WILLIAMSON COUNTY, TEXAS
CHANGE ORDER NUMBER: 1

Project:	<u>Forest North Phase 3</u>
Roadway:	<u>Drainage Improvements</u>
CSJ Number:	<u>3866</u>

Forest North Drainage Phase 3 Williamson County Project No. 3866

Change Order No. 1

SHEET
C-104
7 of 75

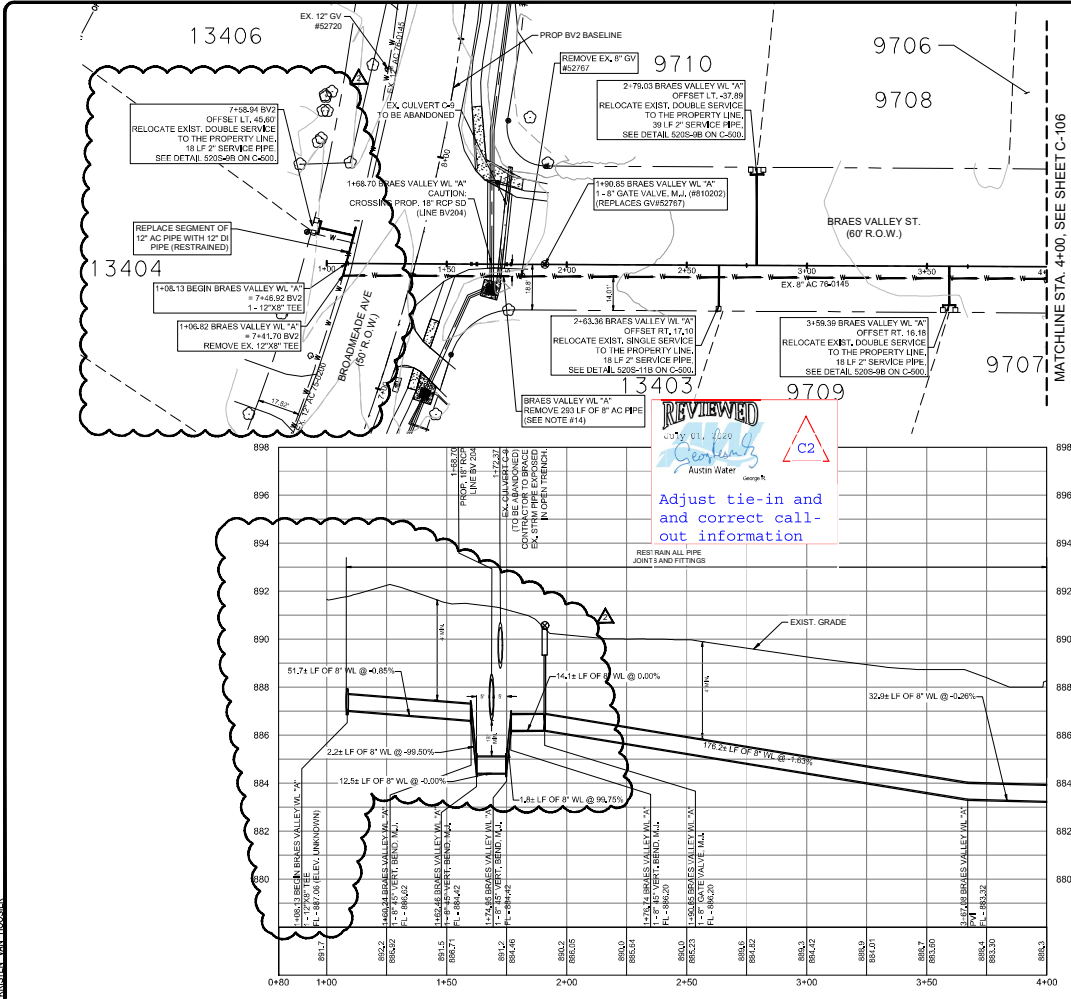
When potholing the existing water line on Broadmeade Avenue at Wisterwood Street, it was discovered that the existing COA water line is a 12" water line instead of an 8" water line as indicated in the plans. The 12" pipe removal, 12" pipe and connections will be added to the Contract. This Change Order also adds a new 2" Double Service connection for an existing service relocation. The pricing for the new items is considered fair and reasonable based on comparison to similar existing item pricing in the Contract and the small quantity involved.

C-105
8 of 75

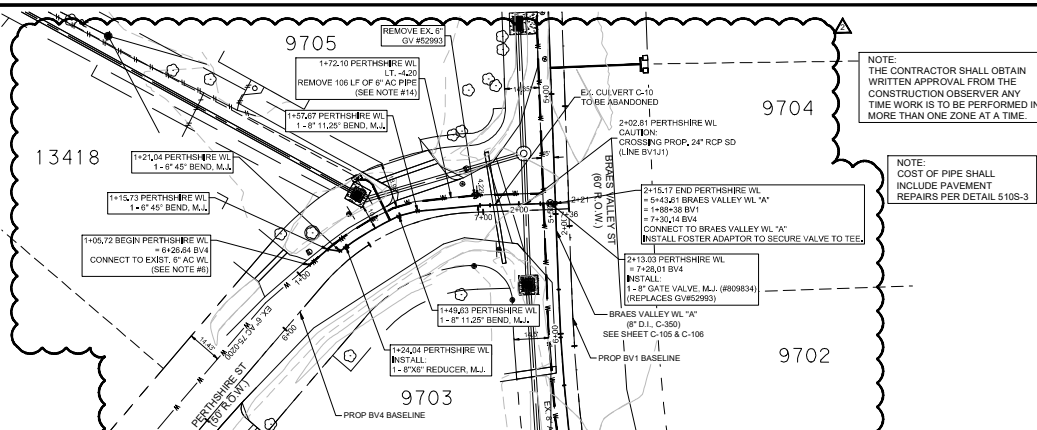
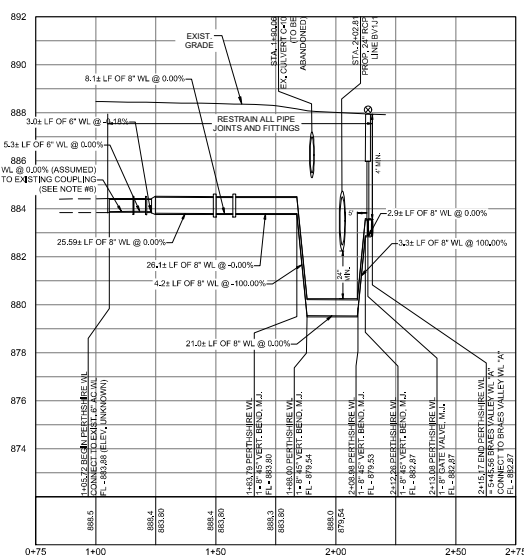
Revise connections due
field conditions
